Access Compliance Report

Public Rights-of-Way

(Curb Ramps)

Intersection ID: 43842	Main Street: BRADSTREET_COMMONS_WY	Cross Street: DELUCA_DR	Location: NE
ADA ID: 6FA5E7CEC99C	Ramp Type: PerpDiag	Initial Pass/Fail: Fail	Overall Compliance: No
Severity Score: 10			
Codes/Mitigation Info/Possible Solution		Field Measurements/Component Compliance

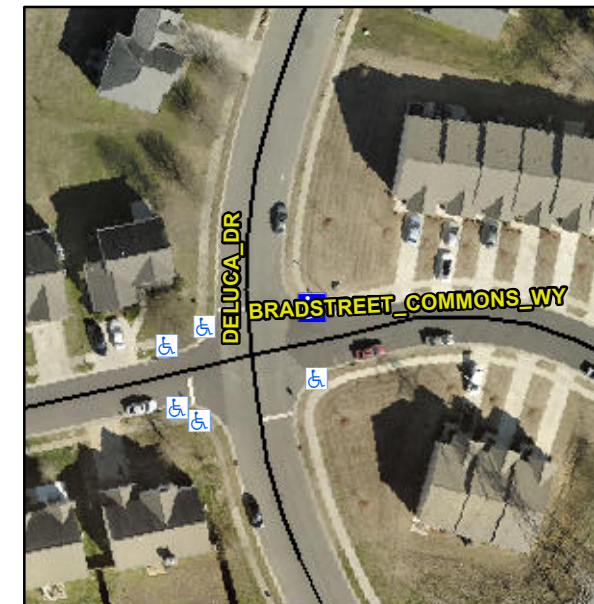
Not Found, R304.5.1, R304.5.3

Compliance	Description	Data	Compliance	Description	Data
N/A	Ramp Length (in)	47.5	Yes	Ramp Slope (%)	7.1
No	Ramp Width (in)	47.0	No	Ramp XSlope (%)	4.3
N/A	Flare Type LT	N/A	N/A	Flare Type RT	N/A
N/A	Flare Slope LT (%)	N/A	N/A	Flare Slope RT (%)	N/A
N/A	Flare Traversable LT?	N/A	N/A	Flare Traversable RT?	N/A
N/A	Landing Length (in)	N/A	N/A	DWS Provided?	N/A
N/A	Landing Width (in)	N/A	N/A	DWS Contrast?	N/A
N/A	Landing Slope (%)	N/A	N/A	DWS Length (in)	N/A
N/A	Landing X Slope (%)	N/A	N/A	DWS Full Width?	N/A
N/A	Landing Curb? (Y/N)	N/A	N/A	DWS Offset (in)	N/A
N/A	Shared Landing?	N/A			
N/A	Gutter Ponding?	N/A	N/A	Gutter Slope (%)	N/A
N/A	Gutter Lip Ht (in)	N/A	N/A	Gutter X Slope (%)	N/A
N/A	Painted X Walk1?	No	N/A	Painted X Walk2?	No
	X Walk 1 Direction	To S		X Walk 2 Direction	To W
N/A	X Walk 1 Width (in)	N/A	N/A	X Walk 2 Width (in)	N/A
	X Walk 1 Slope (%)	3.3		X Walk 2 Slope (%)	5.2
	X Walk 1 X Slope (%)	5.4		X Walk 2 X Slope (%)	2.5

N/A	Ramp inside XWalk1?	N/A	N/A	Ramp inside XWalk2?	N/A
	Road Slope (%)	4.5	N/A	Clear Space?	N/A
	Road X Slope (%)	5.2	N/A	Clear Space to XWalk (in)	N/A
N/A	Any Obstructions?	N/A	N/A	Storm Grate/Utility Hazard?	N/A
	Obstruction Type			Storm Grate/Utility Type	
		N/A			N/A
			Yes	Surface Condition? (G/P)	Good

Remove & Replace Curb Ramp With Two New Directional Ramps or Equivalent.
